Memorandum

Project Name: Green Ridge Recycling and Disposal Facility

Subject: JPA response - Miller Lane Realignment

FIGURE 3 – PART A 2021 LAYOUT OF MILLER LANE RELOCATION

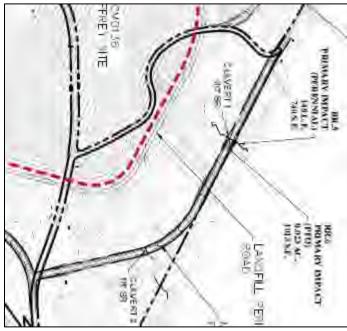
JPA Comment 1 – Item 3: "Please describe the onsite measures used to avoid or minimize impacts associated with the Miller Lane relocation which now results in surface water impacts that were not previously identified."

On October 1, 2021, a revised map was provided to VDEQ for the Part A application after further considering the layout and operations of the landfill. Below is a snip from the 10/1/2021 figure illustrating the relocation of Miller Lane to the outer edge of the Green Ridge property. (FIGURE 3) This alignment was also included in the January 11, 2022 design drawings submitted in response to DEQ comments on the JPA (FIGURE 4).

The Part A and JPA drawings are now consistent. Note that the impact to wetlands is 0.023 acres, well below the 2 acre maximum allowed for landfills and the stream impact is approximately 1% of the total impacts. We believe there is adequate justification for the impacts based on the landfill design and Part A permit requirements as well as VDOT standards.
